Subject: AIR TEMPERATURE COMING FROM CENTER VENTILATION GRILLE IS DIFFERENT ON LEFT AND RIGHT	Bulletin No.: 07-005/24
	Last Issued : 10/09/2024

2024 CX-90 with VINS lower than JM3KK*****161691 (produced before March 6, 2024)

2025 CX-70 with VINS lower than JM3KJ*****101621 (produced before March 2, 2024)

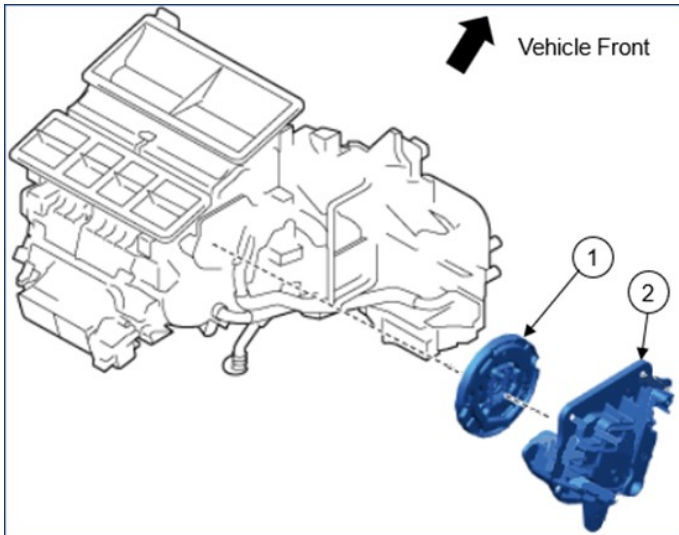
Some vehicles may exhibit different air temperature coming from the center ventilation grille on the left and right. This is caused by the mixing control of hot and cold air not being correct. To eliminate this concern, the air control unit has been modified to improve the air mixing control by adjusting the vent door's opening angle.

Location of the mode main link

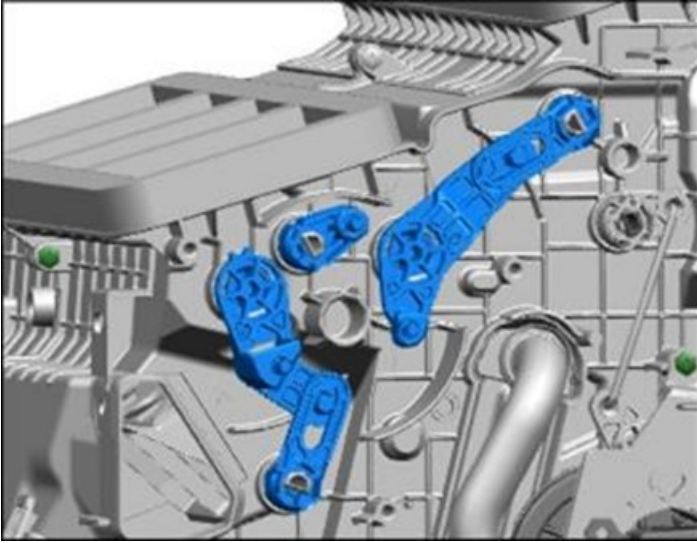
1. Verify the customer concern.
2. Replace the mode main link with the modified one according to the following procedures.

NOTE: Modified Service Part (Mode Link Set) includes the mode main link and 5 other links. When replacing it, use only the mode main link, and discard the other 5 links.

- DO NOT remove the 5 links (blue parts in the image) from the vehicle and DO NOT use the new links in the service parts kit.

View of A

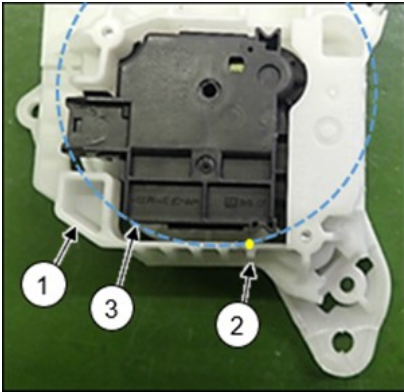
1) Visually confirm the location to be marked on the mode main link as shown in the image (red dot).

Location of the marking is the intersection of the mode main link and the extension line of the front most rib (4) on the airflow mode actuator component.

Sample of mode main link after marking

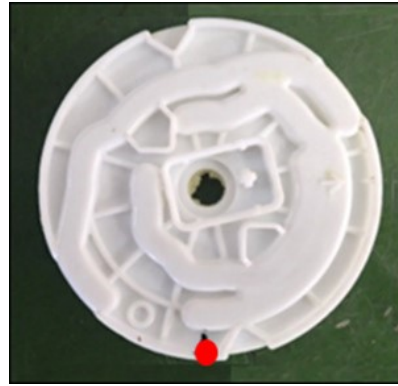
3). Mark on the mode main link to align the angle.

- If the mode main link and the airflow mode actuator component are removed together, mark on the removed mode main link as shown in the images below.
- If the mode main link remains on the A/C unit, remove the mode main link from the A/C unit and install it to the airflow mode actuator component. Mark on the mode main link as shown in the images below.

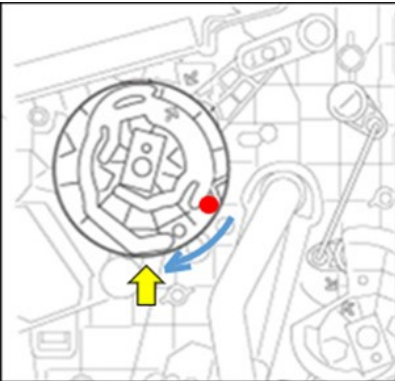
- f. Rotate the main mode link by hand and align the marking to the lowest position (yellow arrow).
